Determination 2020/011

Regarding the refusal to issue a code compliance certificate for a relocated house with 19-year-old alterations and additions at 215 Horndon Street, Darfield

Figure 2: The house as completed

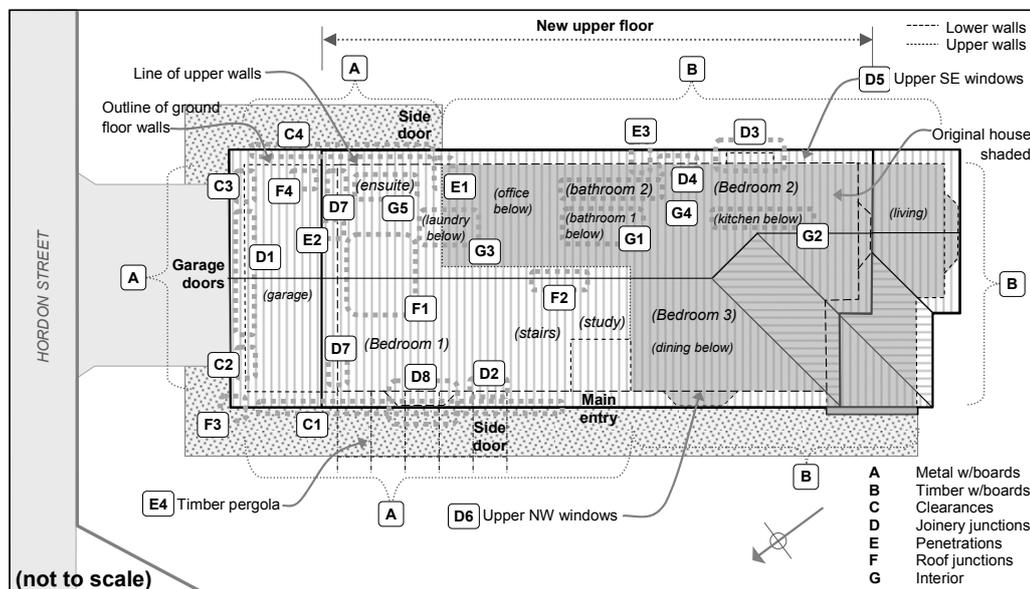
- 3.6.1 The applicant applied for a code compliance certificate on 10 October 2016 and the authority inspected the house on 13 April 2017 and noted the outcome of the inspection as “fail” and the inspection notice identified the following items (in summary, with areas located in Figure 2 noted in brackets):

- 1.1, 1.2 Metal weatherboards used in lieu of timber (Areas A)
- 1.3 Cladding clearance to paving (Area C1)
- 1.4 Metal weatherboard joints opening (Area A)
- 1.5 Head flashings upstands not under cladding (Areas D1 to D8)
- 1.6 Vent not vermin proof (Area E1)
- 1.7 Lack of access to inspect roofs
- 1.8 Timber shingles to gable ends
- 1.9 Cladding recently repainted
- 1.10 Second hand windows installed
- 1.11 Surface water riser level with surrounding paving (Area F3)

2.1 to 2.4, 2.6 Ground floor bathroom layout (Area G1)

2.5 Kitchen renewed since earthquake (Area G2)

2.7, 2.8 Laundry tub to be secured (Area G3)

2.9 Upper level bathroom layout (Area G4)

2.10 Tanking to tiled showers (Areas G1 and G5)

2.11 Ensuite bathroom (Area G5)

Item	Authority’s concerns	Area	Applicant’s comments (4 February 2019 and 12 May 2019)
1. External			
1.1 1.2	Metal ‘weatherboards’ used in lieu of timber	A	<ul style="list-style-type: none"> • Metal cladding installed temporarily, with timber to be installed in future • Agreed to by inspector prior to interim code compliance certificate • Cladding has been performing well

1.3	Insufficient cladding clearance to paving	C1-C4	<ul style="list-style-type: none"> • Now rectified (concrete cut away, sealed and filled with gravel)

1.4	Metal ‘weatherboard’ joints opening	A	<ul style="list-style-type: none"> • Unchanged since interim code compliance certificate • Performing well for past 19 years

1.5	Head flashings upstands not under cladding	D1-D7	<ul style="list-style-type: none"> • Unchanged since interim code compliance certificate • Performing well for past 19 years

1.6	Vent not vermin proof	E2	<ul style="list-style-type: none"> • Now rectified
1.11	Surface water riser level with surrounding paving	F3	<ul style="list-style-type: none"> • Now rectified
Internal

Inspection notice 13 April 2017		CI.	The expert's comments (in summary)	Area reference
1. Exterior				
1.1 1.2	Metal weatherboards used in lieu of timber	E2	<ul style="list-style-type: none"> No evidence of past or present moisture ingress Invasive readings all below 12% Cladding meeting performance requirements 	Area C1

1.3	Clearance to paving	E2	<ul style="list-style-type: none"> Concrete paving had been cut away from walls, a liquid applied membrane applied to edge of foundations and drainage stones laid in trench Invasive readings in adjacent framing all below 14% Timber garage door reveals are in contact with drainage stones which were to be lowered to provide clearance to the reveals 	Areas C1 to C4

1.4	Metal weatherboard joints	E2	<ul style="list-style-type: none"> Vertical overlaps to two sample joints 85mm and 230mm Gaps at laps at joints will drain condensation which formed on back of the metal on cold days Gaps have and will not compromise weathertightness 	Area A

1.5	Head flashings: <ul style="list-style-type: none"> Garage door Side door/window to garage Kitchen bay window Pantry window 	E2	<ul style="list-style-type: none"> Invasive moisture testing and visual inspection All door and window openings meeting minimum performance requirements, but maintenance recommended to some areas No head flashing to garage door Reliant on flexible sealant No evidence of moisture ingress around door Invasive readings in framing all below 12% Head flashing upstand overlaps cladding Slopes towards cladding – reliant on sealant Invasive readings at lintel below 11%, with firm and clean drill shavings Some protection from eaves about pergola No head flashing to bay window Reliant on flexible sealant to flat top of frame 200mm overhang above provides little protection No evidence of moisture ingress around window Invasive readings in framing all below 12% Head flashing upstands overlap cladding Well protected by 580mm lower eave 200mm above the top of flashing Little risk of moisture penetration 	Area D1 Area D2 (plus below Area D8) Area D3 Area D4

<ul style="list-style-type: none"> Upper south east and north west windows Small upper north east windows Upper north west bay window 		<ul style="list-style-type: none"> No head flashing Heads well protected by 430mm wide eave 90mm above window head Little risk of moisture penetration Head flashing upstands overlap cladding Sheltered by 200mm verge overhang 120mm above No evidence of moisture penetration Little risk of moisture penetration Head flashing installed Flashing upstand extends up behind gutter 	<p>Area D5, and D6</p> <p>Areas D7</p> <p>Area D8</p>

1.6	<p>Other penetrations</p> <ul style="list-style-type: none"> Vent from dryer Vent from ensuite Vent from Bathroom 1 	E2	<ul style="list-style-type: none"> Louvre grille now fitted to dryer outlet, duct well sealed to cladding No sign of moisture ingress Recommend replacing expanding foam at penetrations with flexible sealant Louvre missing Maintenance needed Has been attended to 	<p>Area E1</p> <p>Area E2</p> <p>Area E3</p>

1.7	<p>Roof cladding</p> <p>No access to inspect roof</p> <p>Roof spaces</p>	E2	<ul style="list-style-type: none"> Flashing junctions generally adequately fitted Recommend replacing poorly fitting sheets and replacing loose nails with roofing screws Able to gain adequate view of all roof surfaces Sheet laps poorly fitting above the north end of Bedroom 1 on both north west and south east sides Several loose nails around ridge capping centre Garage and upper storey roof spaces inspected No visual evidence of any moisture ingress to any accessible areas Area above Bathroom 2 where underlay not properly fitted – requires attention 	<p>Areas F1 and F2</p> <p>Area G4</p>

1.11	Surface water riser not sealed	E1	<ul style="list-style-type: none"> PVC extension riser sitting in existing riser Not sealed at the junction, risking water and silt entering drain from paving Paving falling towards junction is below 1m² in area and would take many years to for silt to accumulate and block drain Does not breach performance requirements Maintenance will ensure ongoing compliance 	Area F3
Photo	Photograph of downpipe from upper roof	E1 E2	<ul style="list-style-type: none"> Holes drilled into downpipe extension Can discharge over vulnerable apron flashing Discharge should be directed away from flashing Maintenance recommended 	
Photo	Pergola fixed to wall	E2	<ul style="list-style-type: none"> Pergola fixings penetrate wall cladding Ribbon plate reasonably well protected by 580mm wide eave 350mm above plate No indication of moisture ingress on inside of wall on which pergola mounted Invasive moisture readings into door/window lintel and bottom plate below ribbon plate show no moisture ingress 	Area E4
